Notice of Intent

Sundry ID: 2870062

Type of Action: APD Change

Variance Request for Offline Production Cementing

Process and Equipment

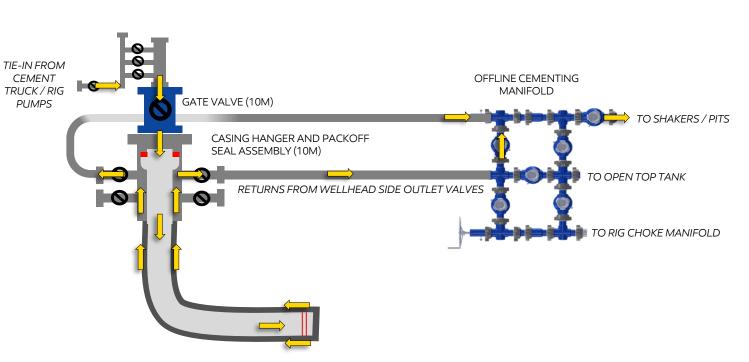
- 1. Rig BOP replaced by gate valve and WH adaptor assembly (10M rated)
- 2. Addition of offline cementing manifold and high pressure iron to direct fluid returns to rig active system and/or choke manifold
- Packoff annulus barrier in place and tested prior to cementing operations (10M rated)
- 4. Cement truck performs cement job displacement (vs rig pumps)
